Access Compliance Report

Public Rights-of-Way

(Curb Ramps)

Intersection ID: 5606	Main Street: JOHN_KIRK_DR	Cross Street: CAMERON_BV	Location:	W
ADA ID: B6D5506279E6	Ramp Type: BlendTrans1	Initial Pass/Fail: Fail	Overall Compliance: No	Severity Score: 1.25
Codes/Mitigation Info/Possible Solution		Field Measurements/Component Compliance

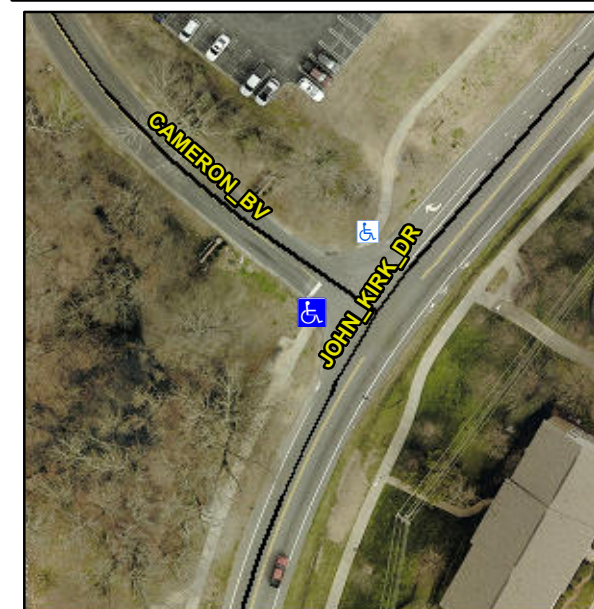
Surveyor Notes:

NO CURB

PROW/ADA:

R304.5.3

Possible Solutions:

Remove & Replace Curb Ramp With Two New Directional Ramps or Equivalent.
